17923 SNUG HARBOR RD

Groundwater & Wastewater Services
Septic Project File & Data Review Worksheet

APPLICATION FOR APPROVAL TO USE AN EXISTING ON-SITE WASTEWATER TREATMENT & DISPOSAL SYSTEM
MECKLENBURG COUNTY - GROUNDWATER & WASTEWATER SERVICES
700 N. Tryon St., Suite 211 Charlotte, NC 28202
Phone: (704) 336-5103 Fax: (704) 336-6894

Re: Application for approval to use an existing on-site wastewater treatment & disposal system.
Property Location: 17923 Snug Harbor Road
Health Department file number: **5719B**

PROPOSED PLOT PLAN

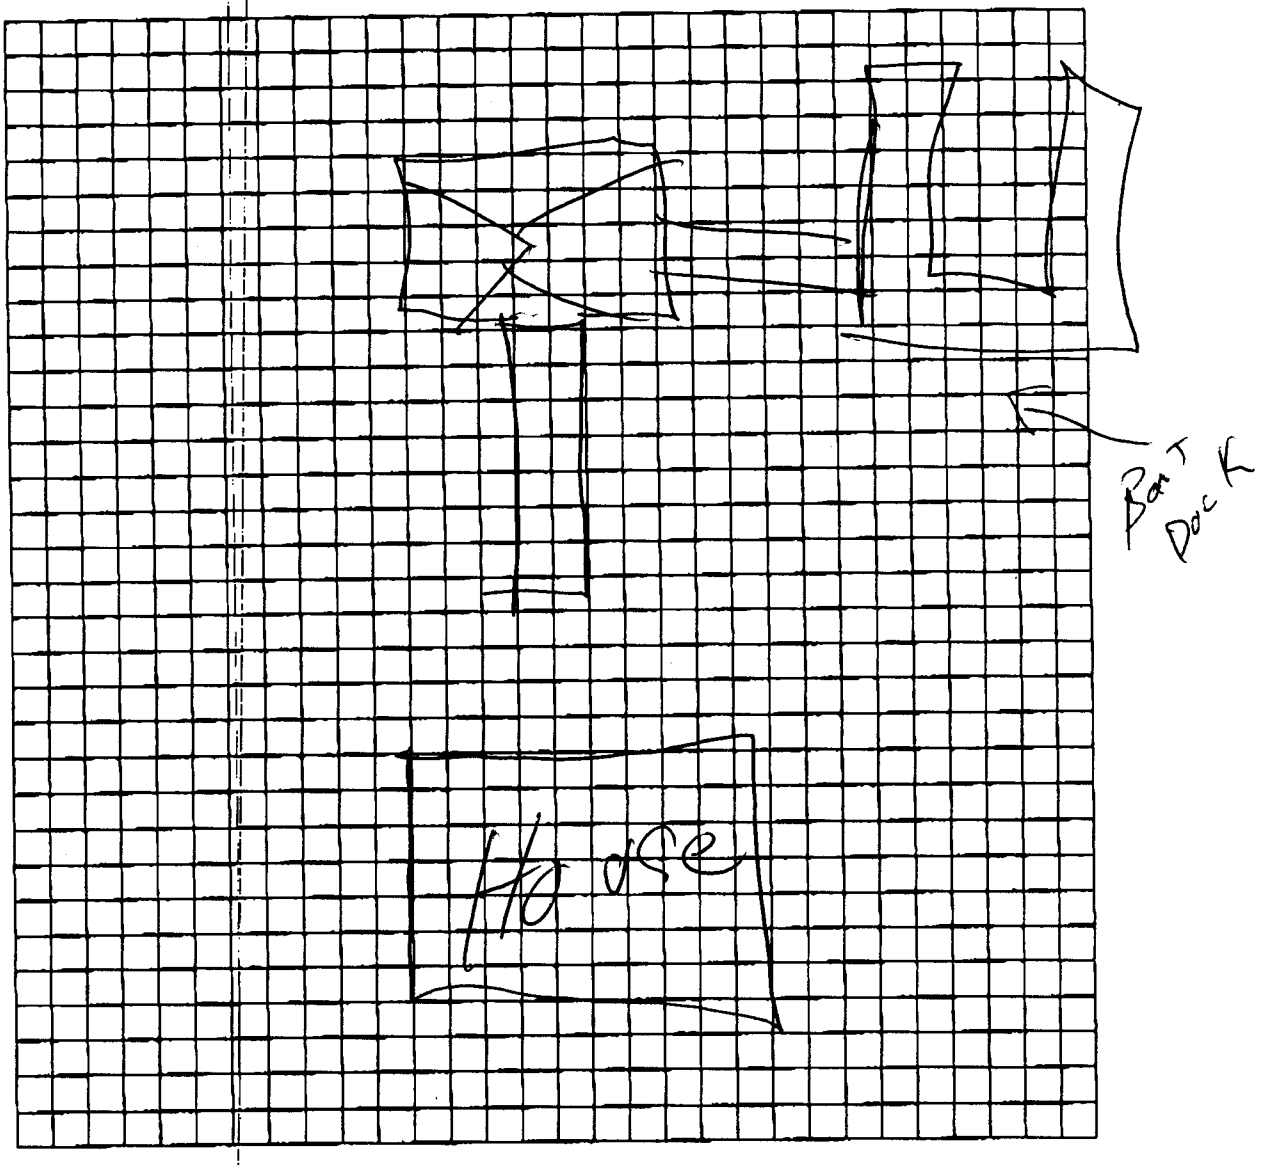
Use existing system for construction of boat dock
System denied due to 4'x92' walkway built over drainfield.

- ☐ The existing on-site wastewater treatment & disposal system was not functioning properly at the time the site evaluation was conducted.
- ☒ The proposed plans do not meet the required setbacks for the on-site wastewater treatment & disposal system serving the property.
- ☐ The proposed plans do not meet the required setbacks for the reserved repair area for an on-site wastewater treatment & disposal system.
- ☐ The proposed plans do not meet the required setbacks for water supply wells.
- ☐ The proposed project will exceed the permitted daily design flow for the existing on-site wastewater treatment & disposal system. System alteration will be required in order to accommodate your proposed project.

PROPOSED PLOT PLAN

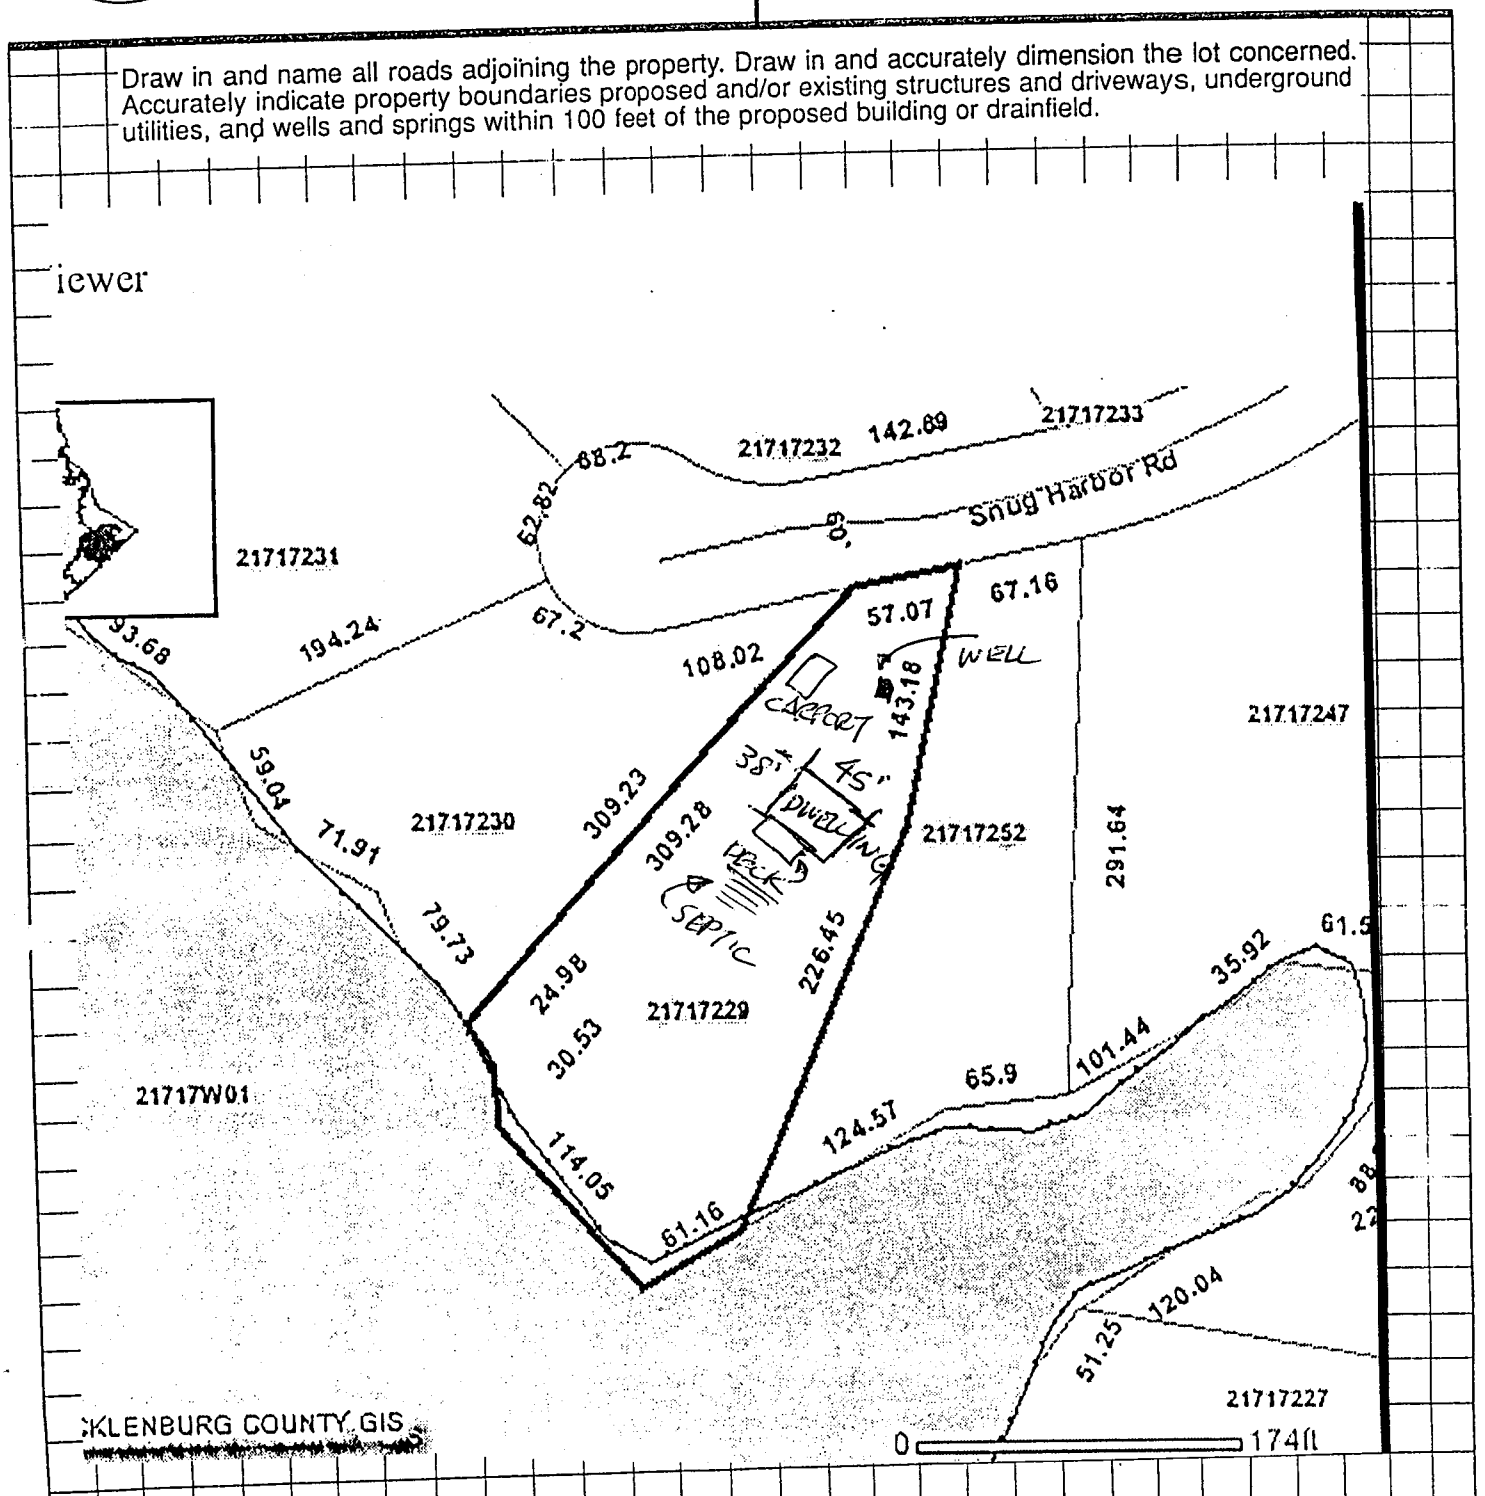
O.K. TO REPLACE EXISTING HOUSE WITH A 3 BEDROOM HOUSE. DISTANCE FROM DRAINFIELD MUST REMAIN THE SAME

Sketch of Soil Evaluation Locations

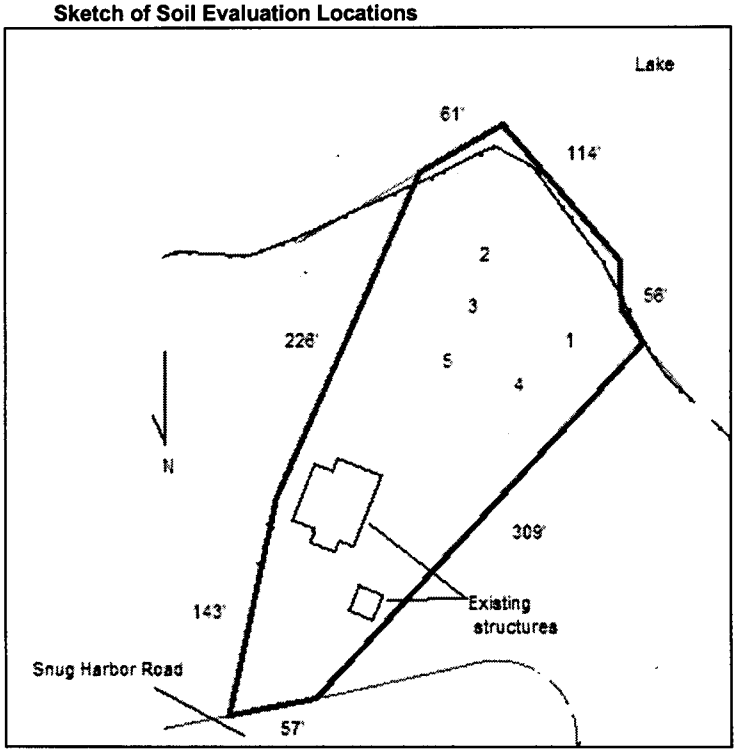
Other Factors (.1946):
Site Classification (.1948): UNSUITABLE
Evaluated By: W. R. Marlin, LSS, 10/18/2004, W. R. Marlin
Others Present: D. Cornelius, S. Miller

COMMENTS:
100% repair
